**SUBMISSION ON THE NSW GOVERNMENT'S  
CROWS NEST TRANSPORT ORIENTED DEVELOPMENT (TOD) REZONING PROPOSAL**

Submission to the Department of Planning, Housing and Infrastructure

Figure C1.1 Concept SSDA (2018) – two residential towers

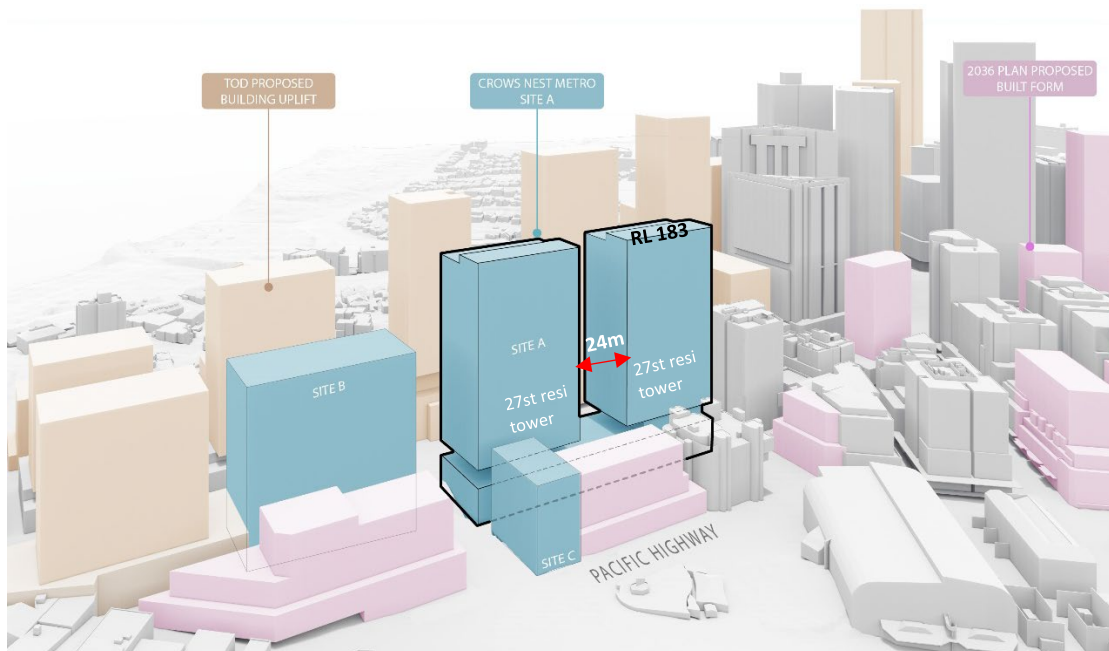
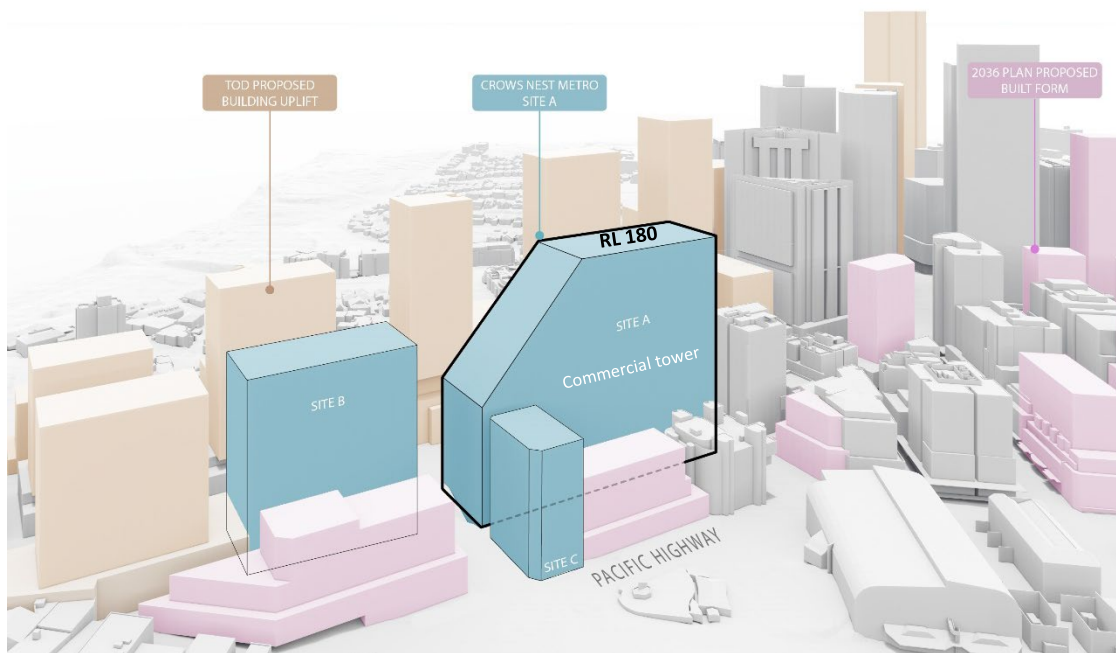
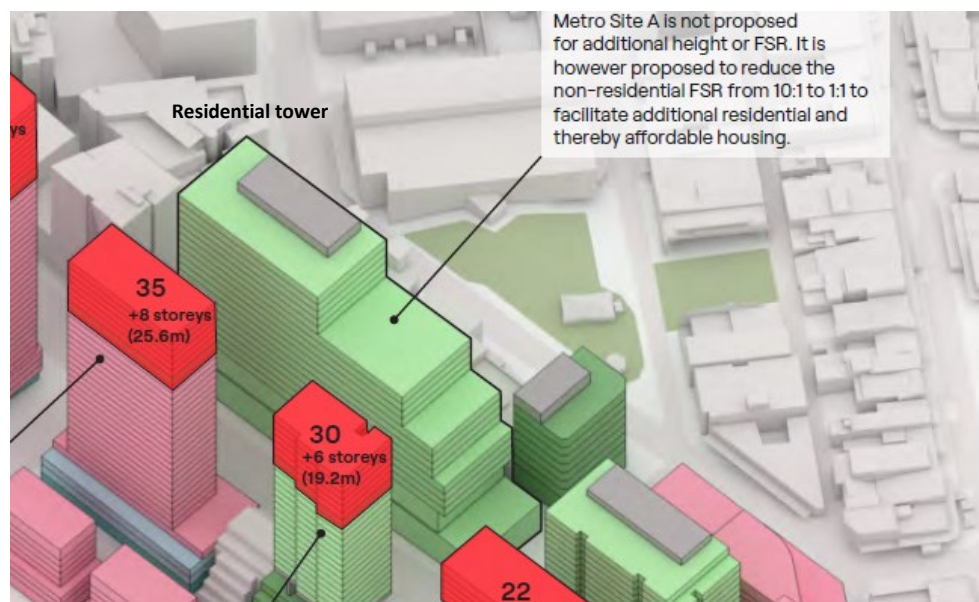
- **Concept SSDA (2018):** The proposed concept scheme included a mixed use development up to 27-storeys in height, with a commercial base and two residential towers with 24m tower separation (refer to Figure C1.1) above. The key concerns raised by Council at the time in relation to the Concept SSDA included:

- the limited employment opportunities and public benefits for the area.
- **Approved building envelope (2020):** In 2020, the NSW Government finalised the 2036 Plan and subsequently amended NSLEP 2013, by implementing the approved built form envelope in terms of building height, FSR and Non-residential FSR for the Crows Nest Station OSD SSDA (refer to Figure C1.2). The proposed increase in non-residential FSR was supported as it provided a significant boost in employment floor space compared to the original SSDA scheme. The main concerns raised by Council in relation to the approved building envelope were:

Package suggests that the built form for Site A will remain as a single tower with a significantly long unbroken façade parallel to the Pacific Highway (refer to Figure C1.3). The key concerns arising from the implementation of the proposed affordable housing incentives on Site A include:

- the scale and massing of the building diminishing the village character of Crows Nest
- the overshadowing effect to Ernest Place and Willoughby Road
- the extensive length of the façade, which lacks any breaks or articulation, overwhelms the street frontage and creates an unwelcoming experience for pedestrians
- the significant decrease in employment floor space, thereby restricting employment opportunities to a highly accessible site and could negatively affect the long-term economic vitality of the region and local area.

Figure C5.3: Sun eye diagram at 4.10pm on 21 Sep - Ernest Place

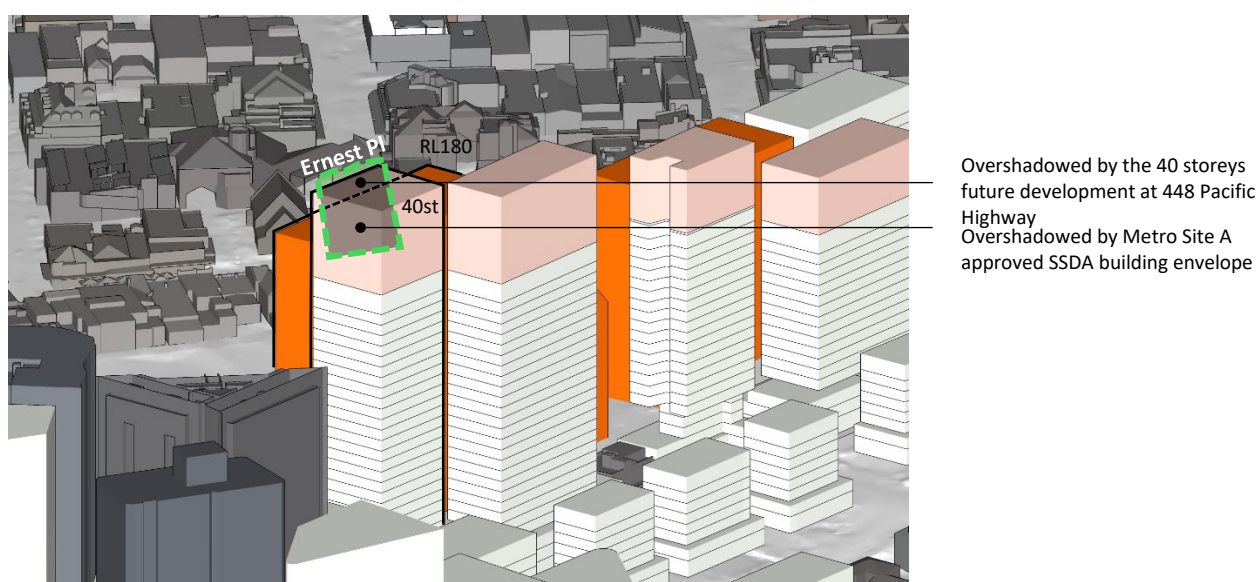
Council has previously advised the Department that the approved Crows Nest metro Site A building envelope has unacceptable overshadowing of Ernest Place and Willoughby Road. Ernest Place currently receives sun up to 5.30-5.45pm at equinox (Figures C5.1 and C5.2). The approved Site A building envelope begins casting shadows on this important open space at 4.10-4.25pm. Sculpting of the envelope would reduce shadows to Ernest Place.

If the affordable housing incentives are taken up at 448 Pacific Highway, it will create additional overshadowing impact to Ernest Place and Willoughby Road, beyond the anticipated impacts of the envelope to Site A of the Crows Nest Metro OSD (refer to Figure C5.3). This additional overshadowing impact is unacceptable as the approved Crows Nest Metro OSD building envelope already creates significant shadow impacts and visual impacts to Ernest Place and Willoughby Road within the Crows Nest village.

**It is recommended that the State Government collaborate with Council to refine the planning controls for 448 Pacific Highway and Site A to the Crows Nest Metro OSD to reduce the overshadowing impacts to Ernest Place and Willoughby Road.**

Figure D2.1 – LEP non-residential FSR map – reduction in non-residential FSR

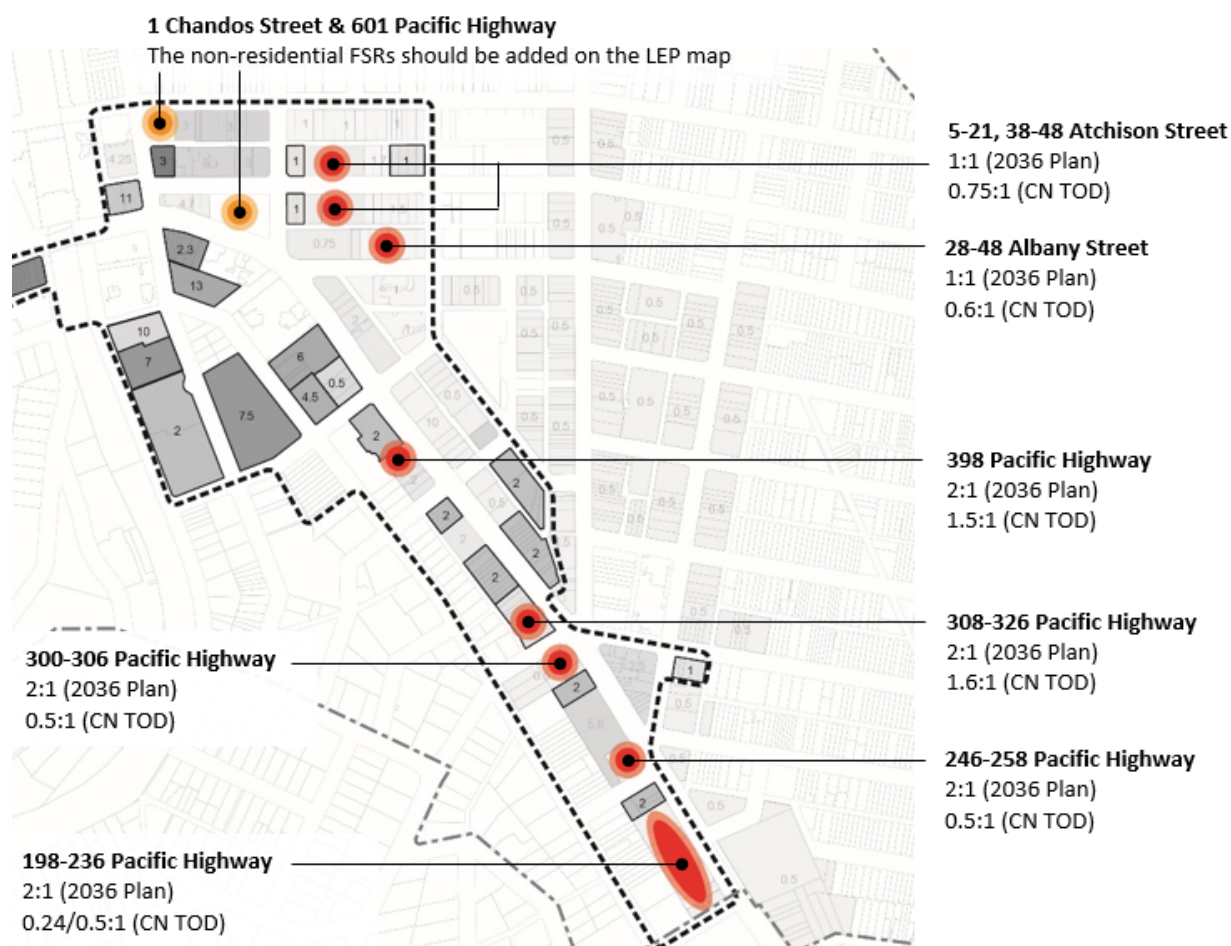
Under the review process, it has been observed that the non-residential FSR for some sites has been reduced compared to the 2036 Plan (see Figure D2.1). While increasing housing supply is a priority for NSW and the proposed uplift aims to address this objective, it should not come at the expense of the non-residential FSR crucial to the Precinct’s commercial vitality. Increased density is anticipated to drive additional demand for retail and commercial services. Therefore, to uphold the Precinct’s designated commercial role, it is essential to retain the non-residential FSR as specified in the 2036 Plan. Council opposes any reduction in non-residential capacity for St Leonards and Crows Nest.

changes, which allow the conversion of commercial land in E2 zones to Build to Rent (BTR) or rental residential purposes, could impact the delivery of commercial uses at 601 Pacific Highway and affect the Precinct's overall commercial offer.

Therefore, it is essential to include the minimum non-residential FSR controls on the map to ensure the preservation and promotion of non-residential uses within this key commercial core area.

Figure E4.1: NSC model of proposed affordable housing bonus heights (Source: North Sydney Council)

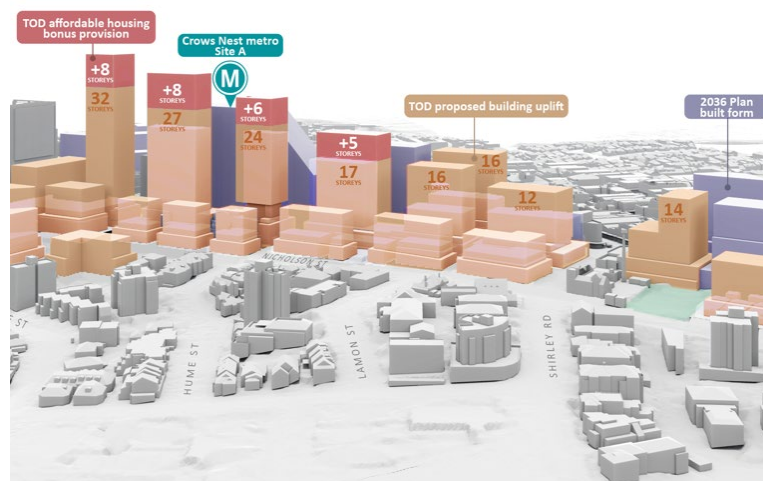
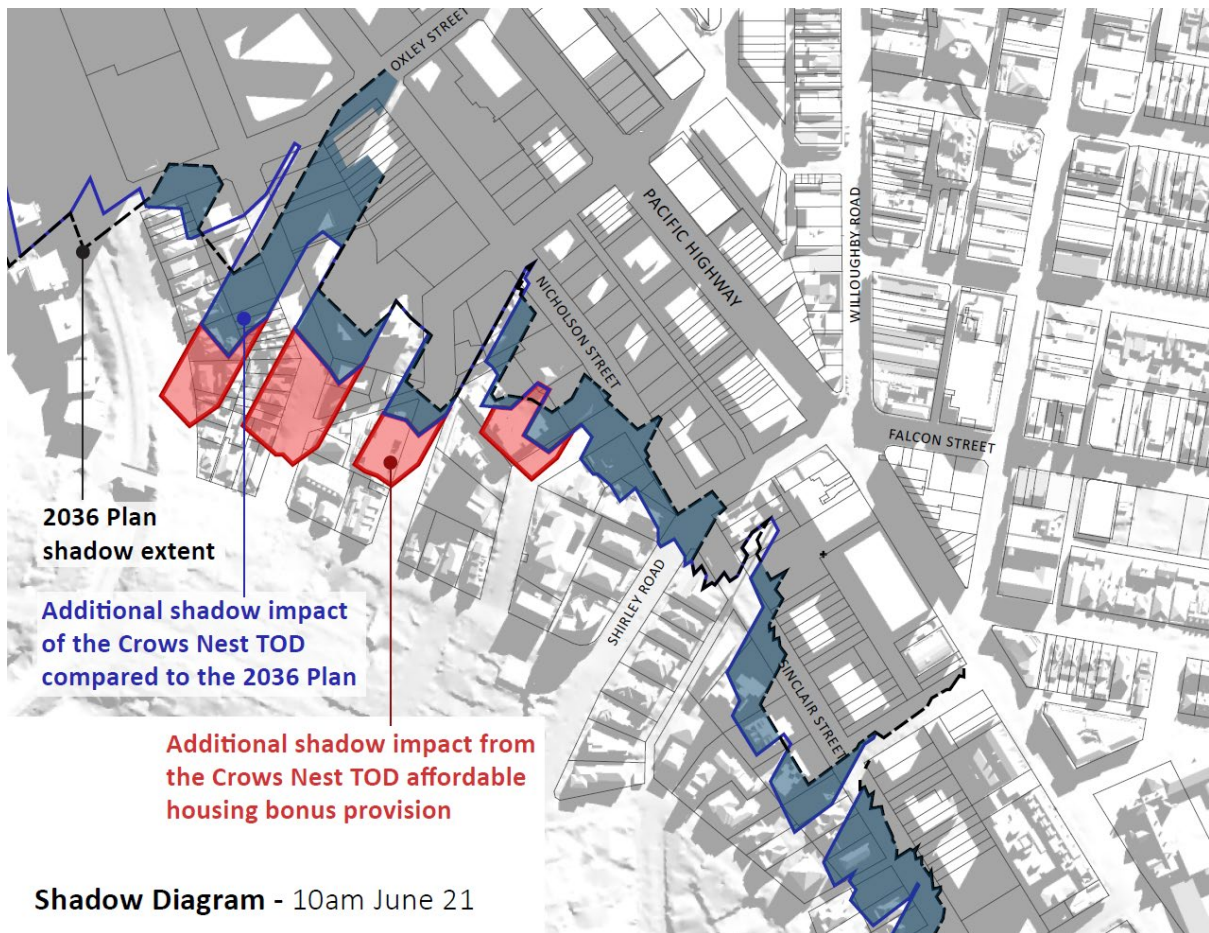
The impacts of the affordable housing incentive bonuses for the four key sites on the south-western side of the Pacific Highway opposite the Sydney Metro station, have been modelled to analyse the shadow impact of the various proposed building heights (Figure E4.1 and E4.2).

Figure K7.1. Right hand turn bans and the existing road network design will encourage rat-running through local streets.

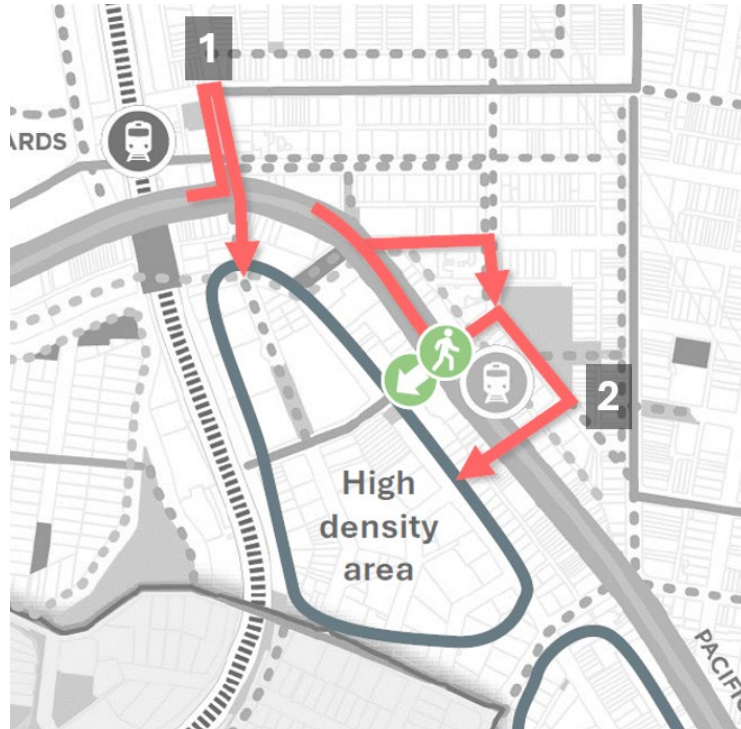
There are existing 'No Right Turn' restrictions for southbound traffic on the Pacific Highway into Hume Street or Shirley Street. Drivers travelling from the north to the proposed uplifted area on the western side of the Pacific Highway will attempt short-cut routes through residential streets to gain access (see Figure K7.1).

This is of concern particularly for the areas that are expected to experience increased pedestrian activity as a result of the Crows Nest Metro Station and increased traffic due to current and planned rates of off-street parking provision within new development. Potential amelioration measures that warrant investigation include:

- removal of the roundabout at the intersection of Chandos Street and Christie Street (identified as point 1 in Figure K7.1) to reduce this travel pattern.
- treatments to minimise through traffic on Hume Street crossing the Pacific Highway (identified as point 2 in Figure K7.1)
- traffic calming measures for the entire precinct to prevent short-cut through movements through local streets. This should include continuous footpath treatments and raised pedestrian crossings on Oxley Street and Clarke Street.
